66000A-06A

S E R V I C E N O T E

66000A DC Power Supply Main Frame

The instrument will not communicate or will not complete self test.

Figure 2

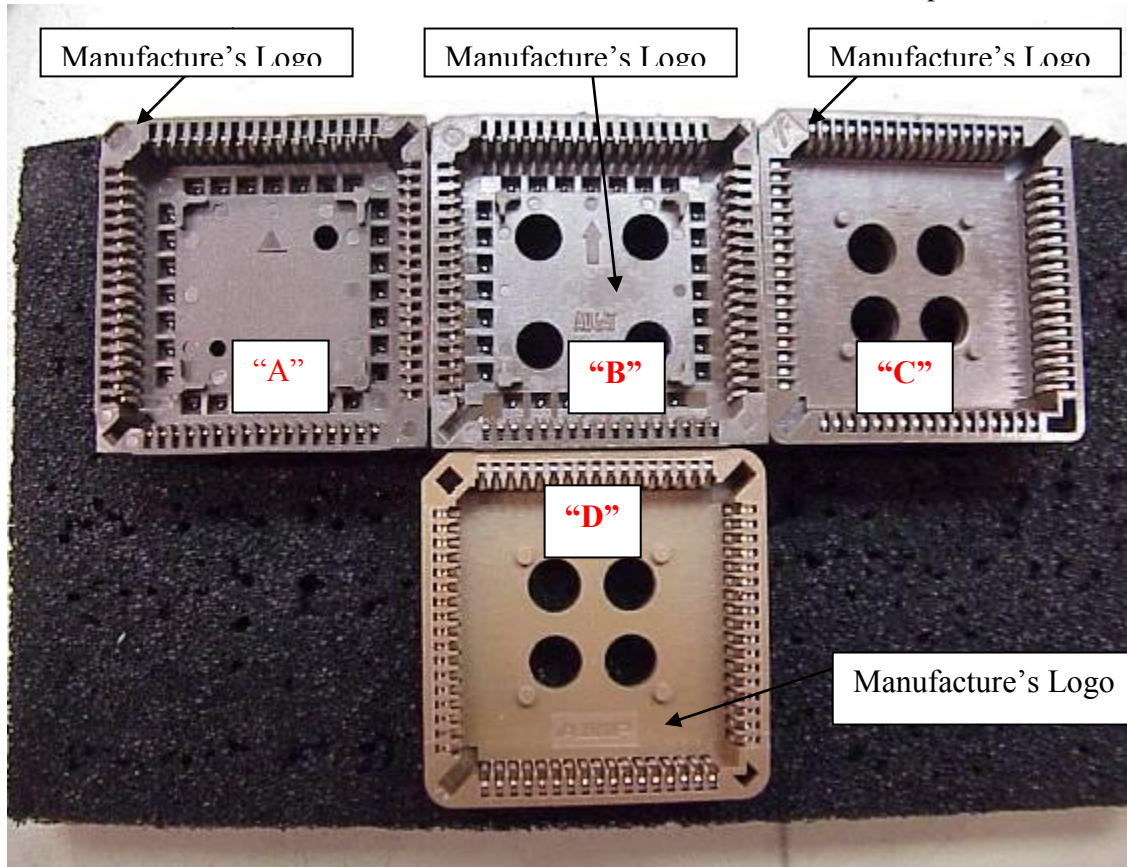
This figure should be used to identify **GOOD** sockets and a potential defective socket. The **16-Bit MCU 16 MHZ 68PLCC CMOS IC** (P/N 1821-1479) is **NOT** pictured.

The following information will help identify each socket type and manufacturer. The manufactures logo can be identified as shown. After the **16-Bit MCU 16 MHZ 68PLCC CMOS IC** has been removed There are also mold markings that can be easily viewed these markings should be used to identify a **Good or Defective socket**.

- Socket **"A"** is a sample of a GOOD AMP socket.
- Socket **"B"** is a sample of a GOOD Tyco/Augit socket.
- Socket **"C"** is a sample of a GOOD FCI socket.
- Socket **"D"** is a sample of a DEFECTIVE Tyco socket.

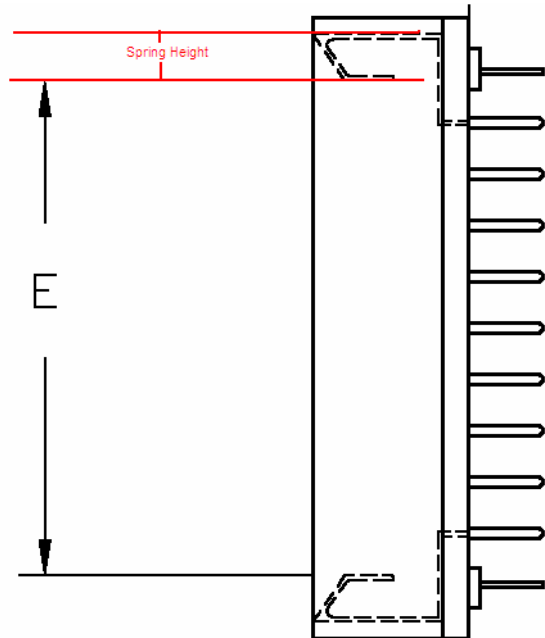
The sockets above labeled **"A", "B" or "C"** are good and should NOT be replaced.
The socket above labeled **"D"** is considered defective should be replaced.

Any Model having a serial number starting and ending with the serial numbers shown in the chart below should have the socket 68-PIN PLCC SOCKET - P/N 1200-1274 (Circuit Reference "U44") **REPLACED!**

Discipline B – Verification of Corrective Action “The socket shown in the pictures are for reference ONLY”

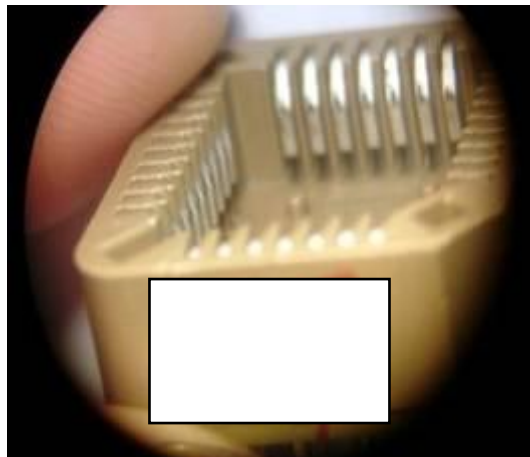
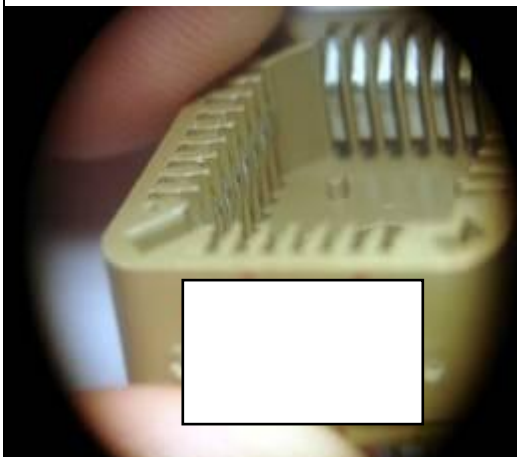
The condition of the recessed beams has been corrected by a design enhancement implemented in production. This design enhancement increased the spring height dimension by 0.04mm and decreased the spring height tolerance by 40%. The spring height dimension is shown in the drawing below.

This design enhancement is intended to position the contact beams closer to the middle of the socket and increase the normal force exerted on the contacts of the chips mated to the socket.

The effectiveness of this design enhancement was tested by comparing the mating and un-mating forces on the older and newer designs. The test results for sockets with the increased spring height (newer design) showed an increase in the mean mating force of 18.9% and an increase in the mean un-mating force of 23.4%. The increase in the un-mating force test results between the old design and the new design indicate that a greater normal force is being exerted on the test chip contacts by the socket contact beams. The two revisions of this contact beam design were visually examined after the mating and un-mating force testing. Photos of the two sockets are shown below. The photo on the left shows the older version socket prior to the enhanced contact beam design. The photo on the right shows a socket with the design enhancement. The contacts with the older design appear to be recessed farther into the housing after un-mating.

Material with this design enhancement will be labeled with a 2007 date code

Tyco suggested we use their p/n 1-571541-3 instead of their p/n 1-822473-6. They claim this socket is more robust.
